UNITED STATES PATENT AND TRADEMARK OFFICE

APPLICATION NO.	FILING DATE	FIRST NAMED INVENTOR	ATTORNEY DOCKET NO.	CONFIRMATION NO.
09/651,334	08/31/2000	Mark J. Bailey	ROC9-2000-0158-IBM-191	3888

Office Action Summary

DETAILED ACTION

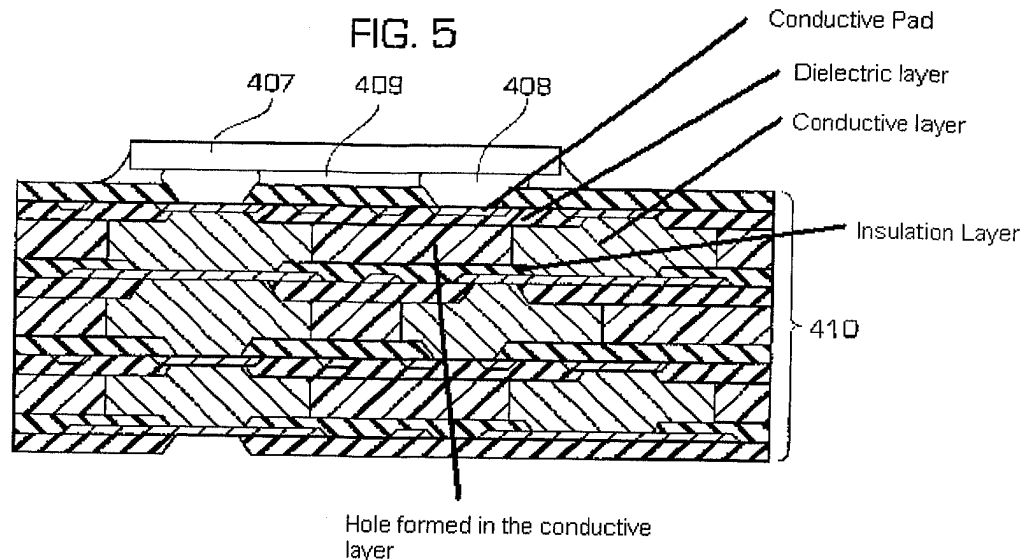
Regarding Claim 1, Tsukamoto teaches a surface laminar circuit board, comprising: an insulating layer (see Figure 5 below); a conductive layer (see Figure 5 below); disposed on an upper surface of said insulating layer, said conductive layer having a hole formed therein (see Figure 5 below); a dielectric layer (see Figure 5 below) disposed on an upper surface of the conductive layer; and a conductive pad (See Figure 5 below) having a majority thereof within an area defined by an outer periphery of the hole, said conductive pad being for receiving a surface mounted component (Reference number 407) thereon.

Regarding Claim 3, Tsukamoto teaches that said photosensitive dielectric layer is in direct contact with the insulating layer by way of the hole (See Figure 5, inside the hole), and wherein said conductive pad (See Figure 5) is disposed directly on an upper surface of said photosensitive dielectric layer (See Figure 5), said dielectric layer separating said conductive pad from said conductive layer and from said insulating layer. (See Figure 5).

Regarding Claim 12, Tsukamoto teaches that said conductive pad (Reference number 306) is disposed completely within the area defined by the outer periphery of the hole. See figure 5.

Regarding Claim 20, Tsukamoto teaches a surface laminar circuit board, comprising: an insulating layer (Reference number 406, below the hole in Figure 5); a signal ground conductive layer (Reference number 404); disposed on an upper surface of said insulating layer, said conductive layer having a hole (the space between the two elements with Reference number 404) formed therein; a photosensitive dielectric layer (Reference number 406, over the hole in Figure 5) disposed on an upper surface of the signal ground conductive layer, said dielectric layer having a photo micro-via (See top portion of insulating layer on top of Figure 5) formed therein; a signal trace (Reference number 1205) disposed on said photosensitive dielectric layer, and being electrically coupled with said signal ground conductive layer by way of said photo micro-via (See Figure 13C); a conductive pad (Reference number 306) having a majority thereof within an area defined by an outer periphery of the hole (See Figure 5), and being electrically coupled with said signal trace; and a surface mounted component (Reference number 407) mounted on said conductive pad.

Regarding Claim 21, Tsukamoto teaches that said photosensitive dielectric layer (Reference number 402) is in direct contact with the insulating layer (Reference number 403) by way of the hole, and wherein said conductive pad is disposed directly on an upper surface of said photosensitive dielectric layer, said dielectric layer separating said conductive pad from said conductive layer and from said insulating layer. See Figure 5.

Regarding Claim 23, Tsukamoto teaches a surface laminar circuit board, comprising: an insulating layer (see Figure 5 above); a sheet of conductive material (see Figure 5 above) disposed on an upper surface of said insulating layer, said sheet of conductive material having a hole (see Figure 5 above) formed therein, the sheet of conductive material completely surrounding an area defined by the hole (See figure 5 above), a dielectric layer (see Figure 5 above) disposed on an upper surface of said conductive material; and a conductive pad (See Figure 5 above) having a major portion thereof disposed directly the insulating layer, said conductive pad being for receiving a surface mounted component (Reference number 407) thereon.

Regarding Claim 24, Tsukamoto teaches that the dielectric layer is in direct contact with the portion of said insulating layer exposed by the hole (See Figure 5, inside the hole), and wherein said conductive pad (See Figure 5) is disposed in direct contact with an upper surface of said dielectric layer, said dielectric layer separating said conductive pad from said conductive material and from said insulating layer (See Figure 5).

Regarding Claims 28 and 29, the modification of Tsukamoto teaches that all of said conductive pad is disposed over the portion of said insulating layer exposed by the hole. (See Figure 5)
